SUBJECT: NEW ORCHARD FARM ELEMENTARY SCHOOL  
ORCHARD FARM R-V SCHOOL DISTRICT  
ST. CHARLES, MISSOURI  
PROJECT # 23-09B

Enclosed please find one (1) electronic .pdf copy of Addendum No. 2, dated August 1, 2024, for the above-named project.

ORCHARD FARM R-V SCHOOL DISTRICT  
NEW ELEMENTARY SCHOOL  
ST. CHARLES, MISSOURI

DRAWN BY Author  
CHECKED BY CW  
SHEET NO.  
M3.5  
SD: 42

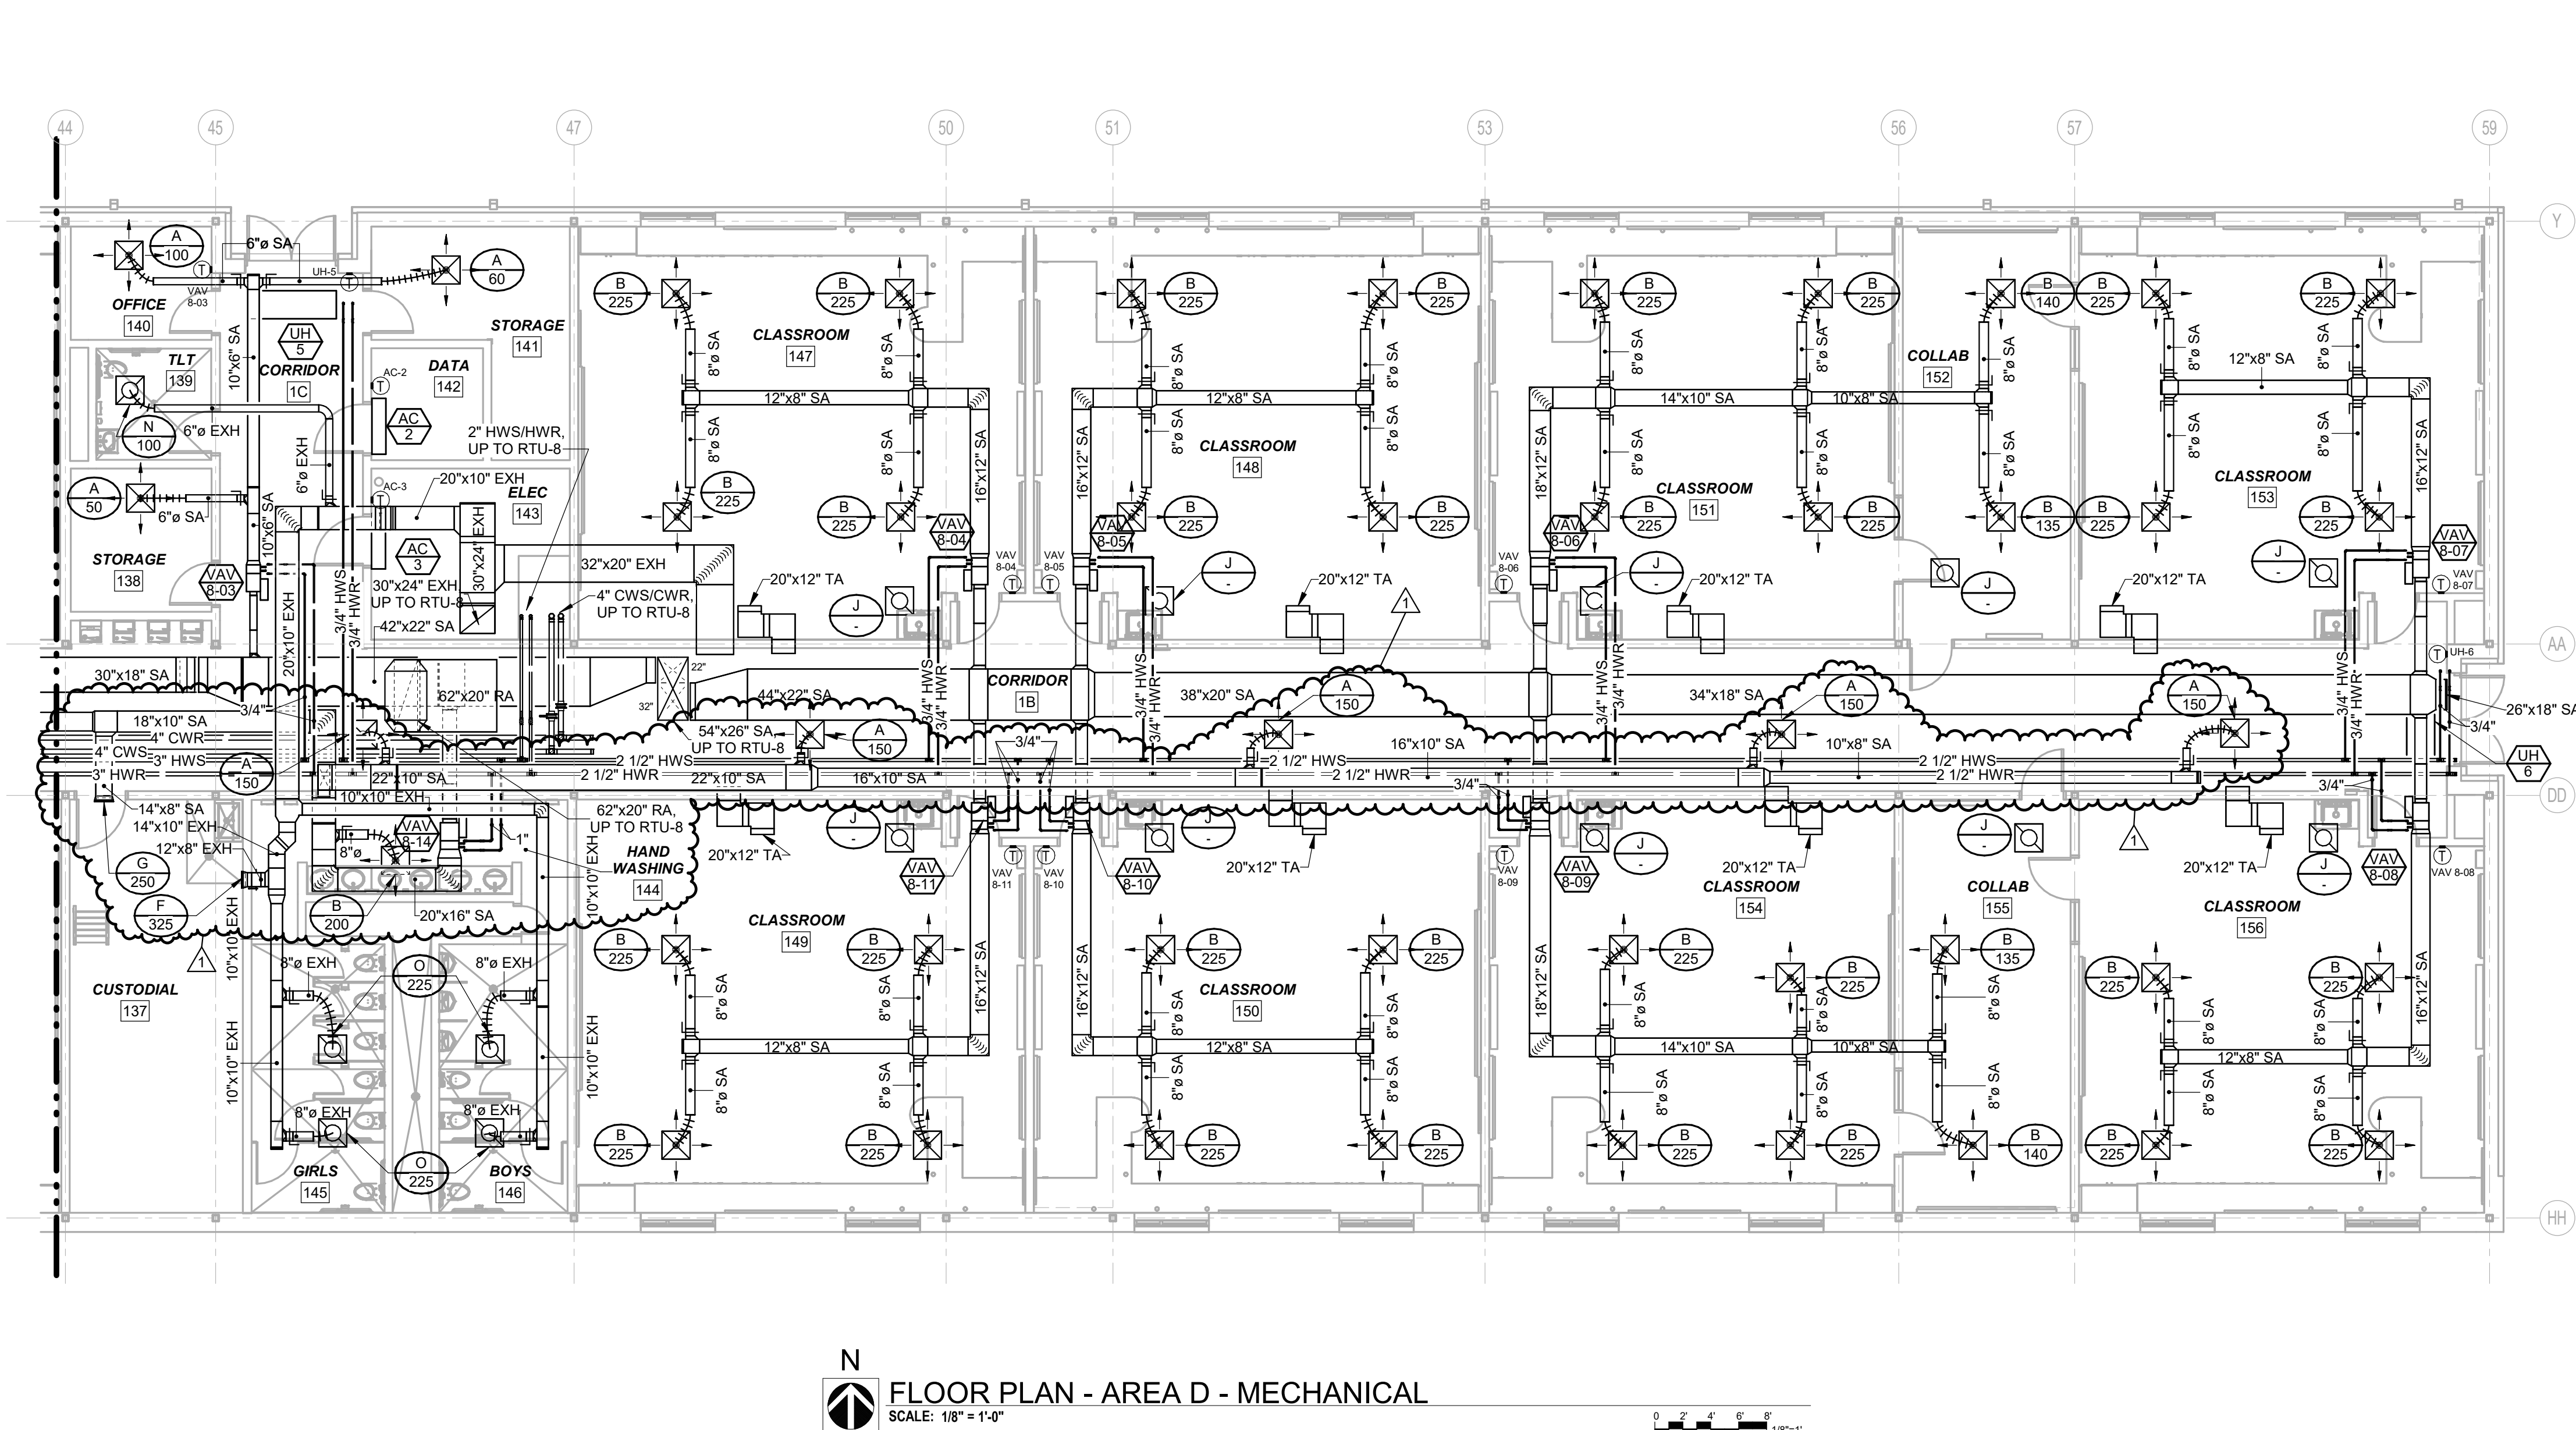
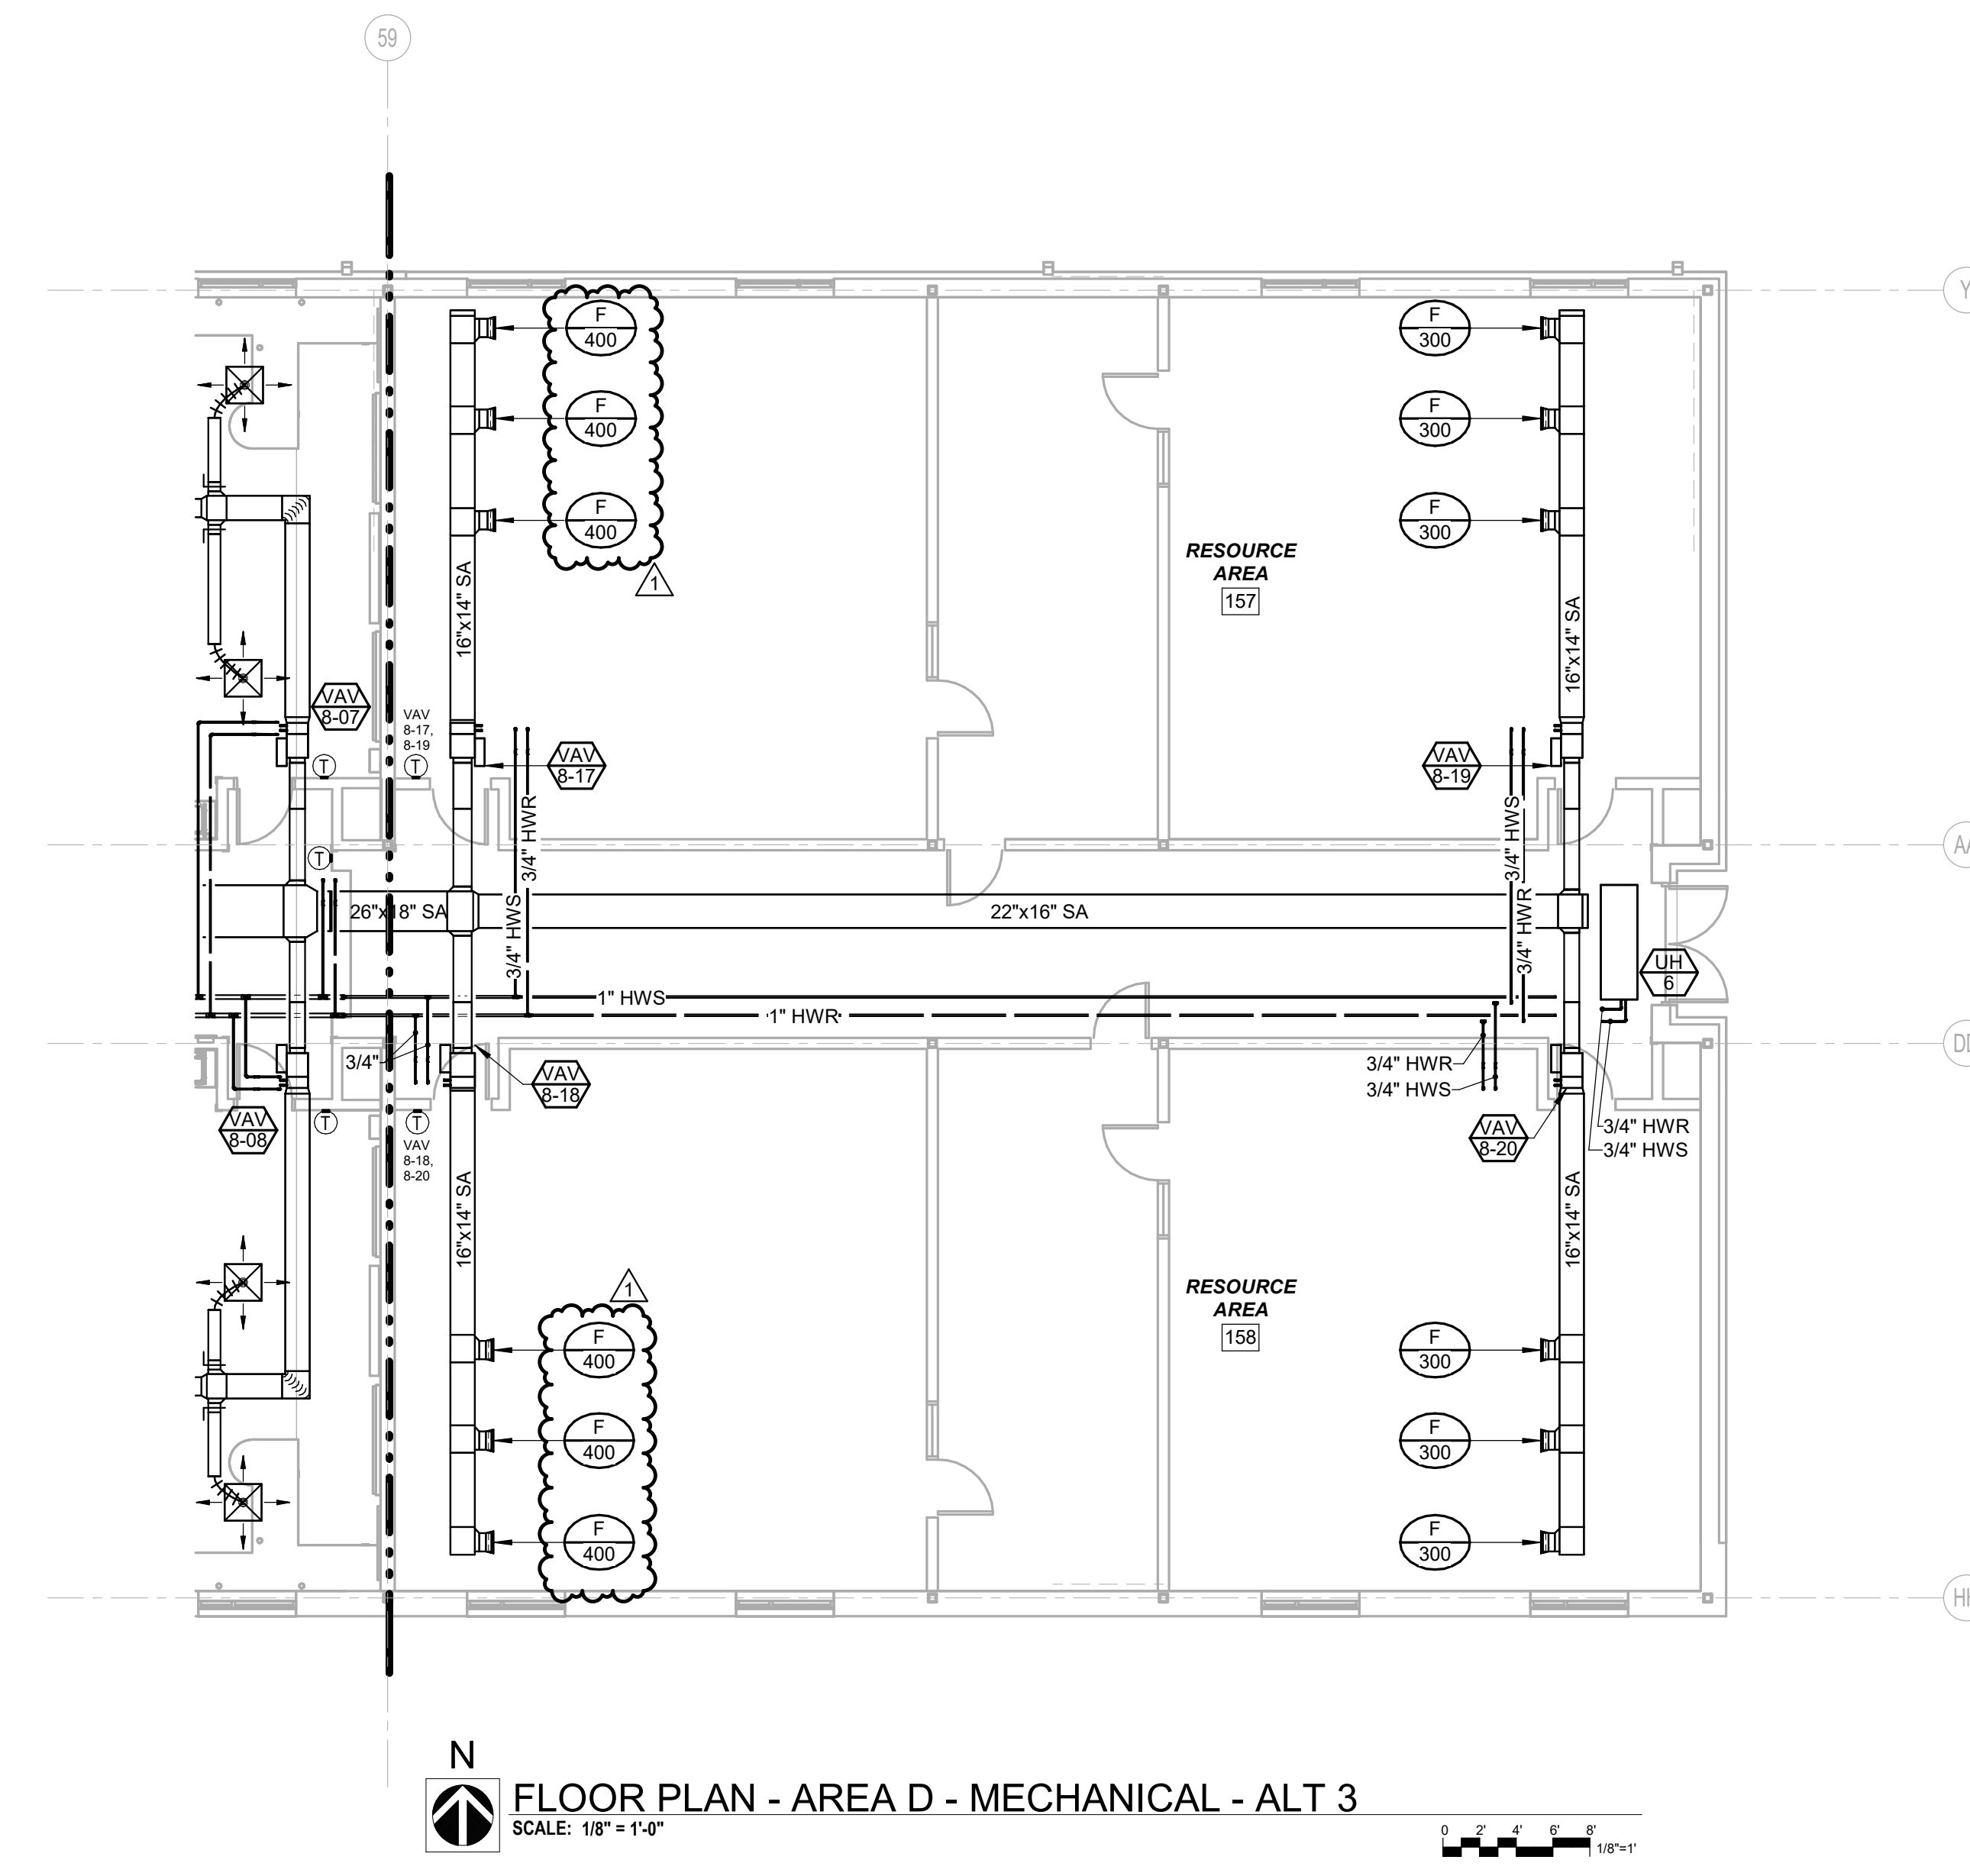
ITEM NO. 22 – MECHANICAL DRAWING SHEET M3.5

- A. **“ADD”** Supply air duct and devices to hand washing 144 and Custodial 137.
- B. **“ADD”** Corridor 1B supply air ductwork.

**M3.13**  
SD: 43

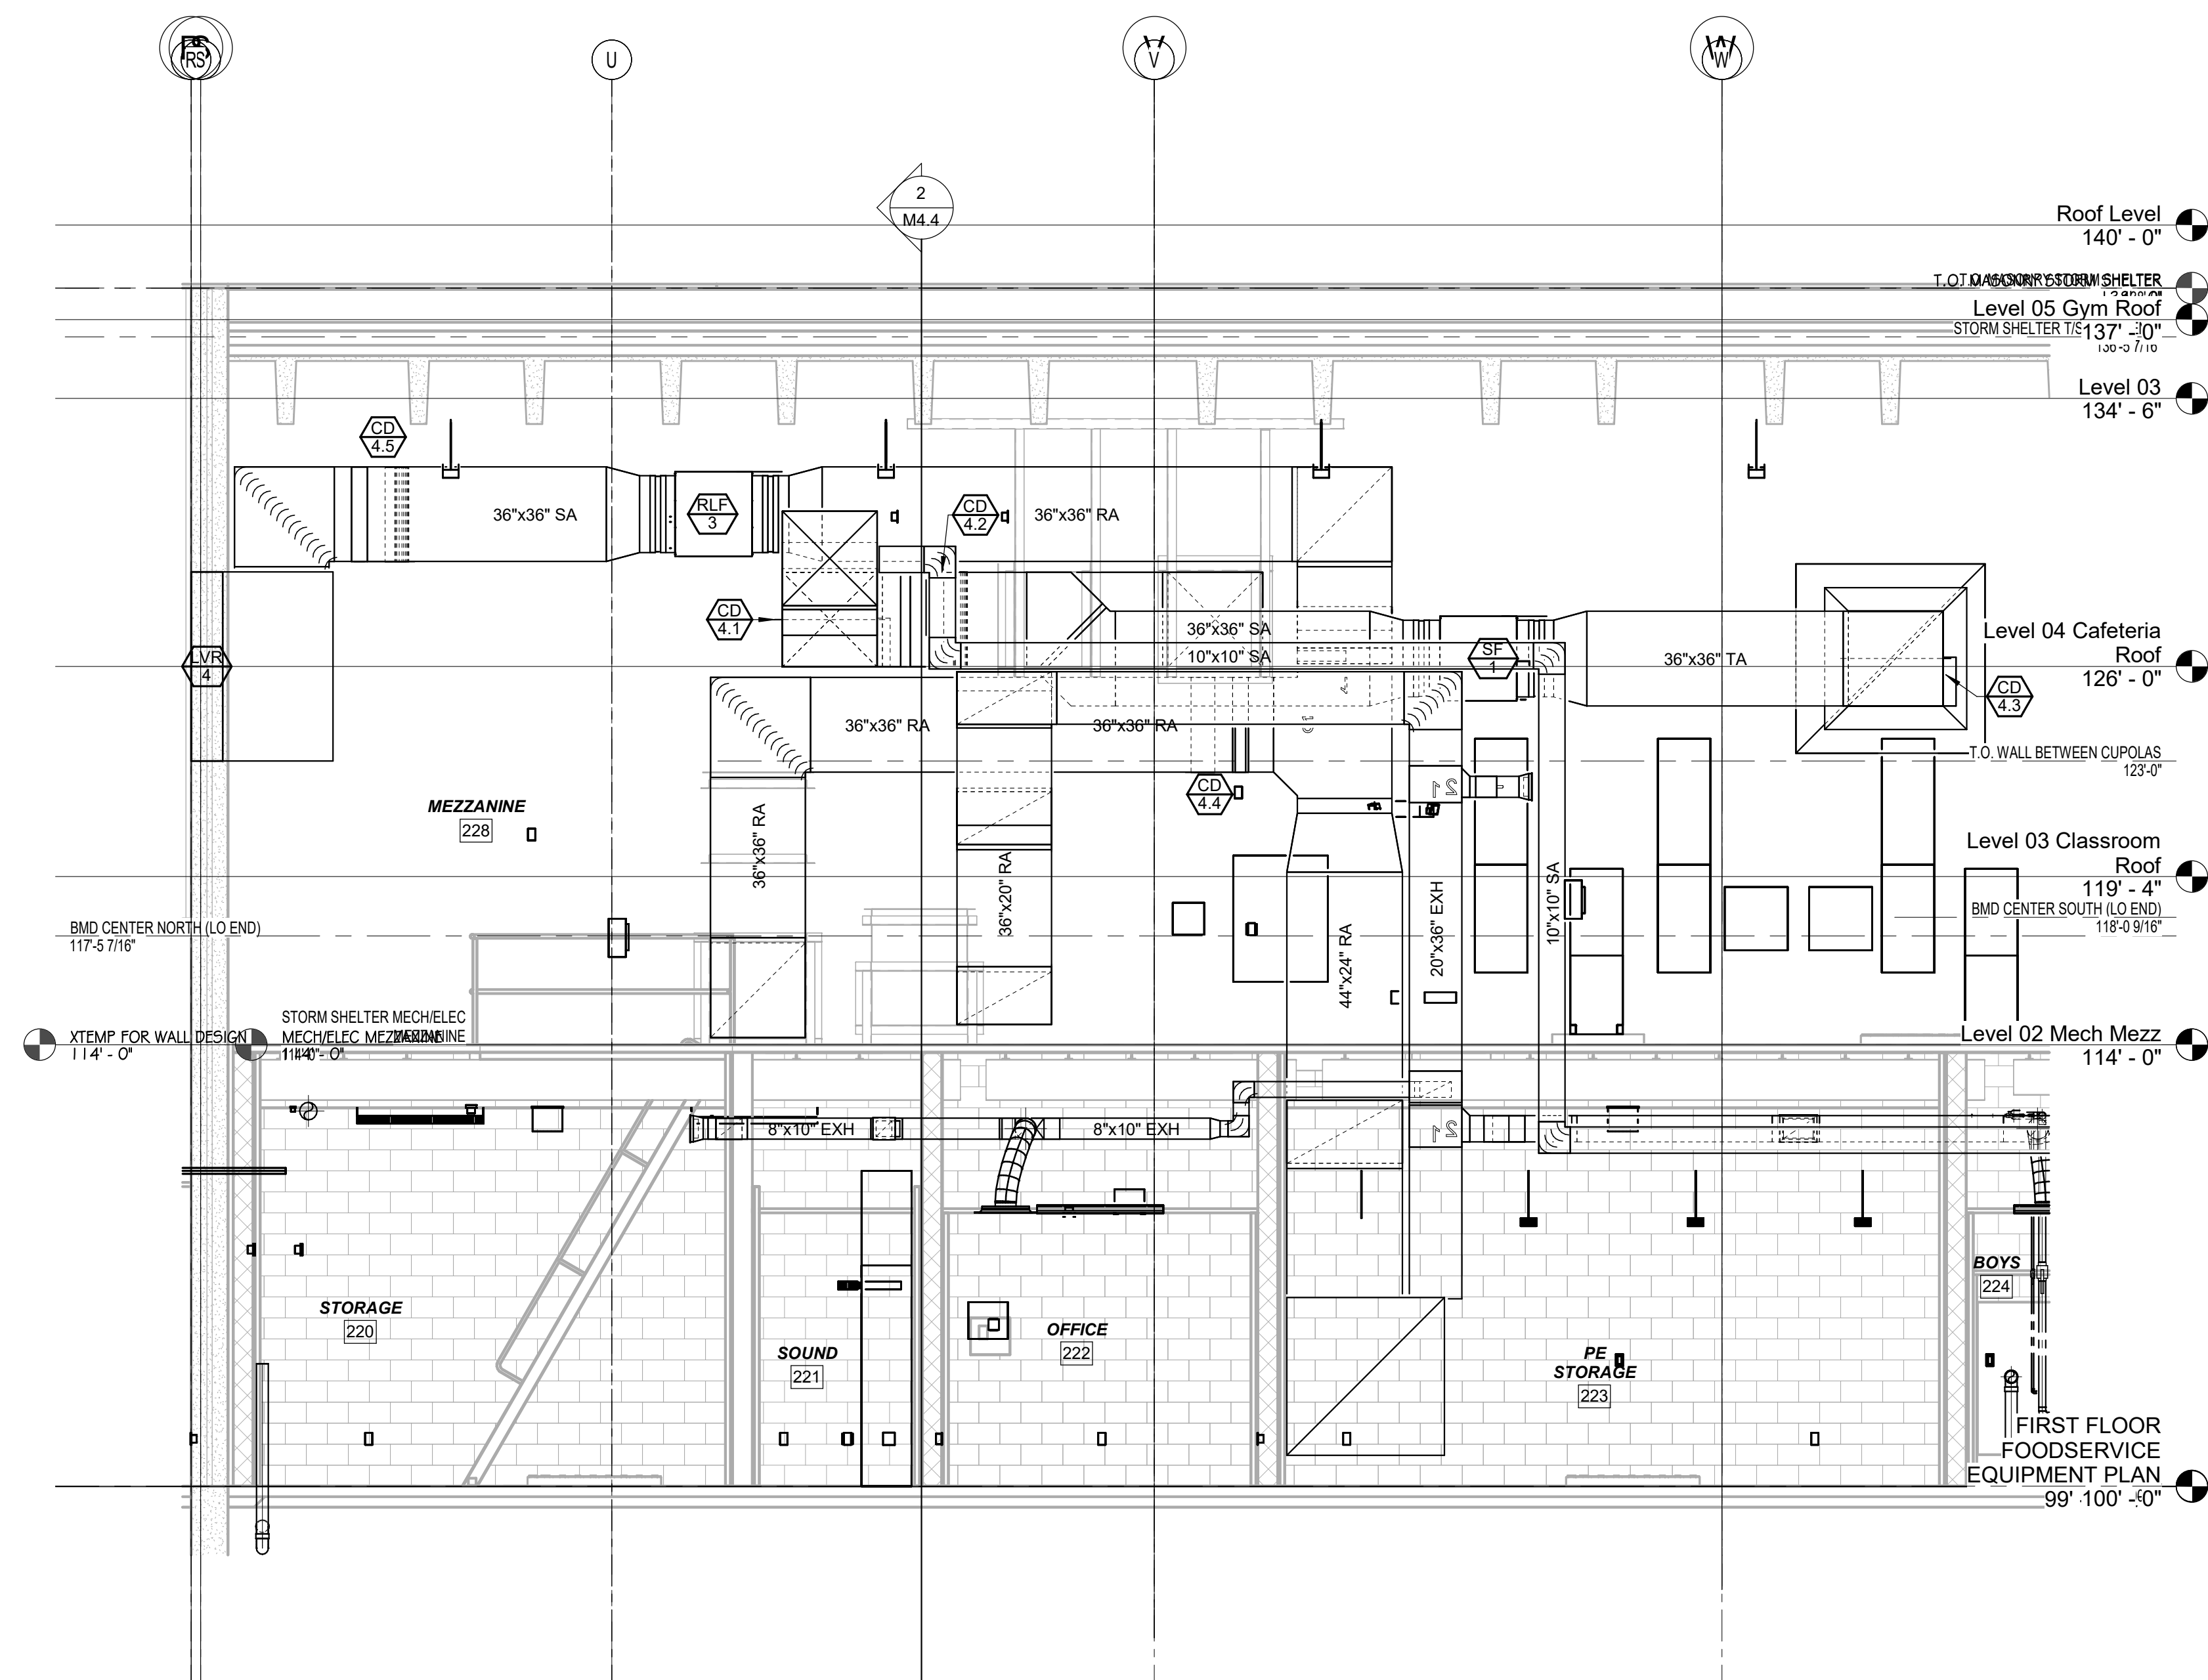
ITEM NO. 24 – MECHANICAL DRAWING SHEET M3.13

- A. **“ADD”** Penetration and gooseneck fitting for Kiln fume exhaust.
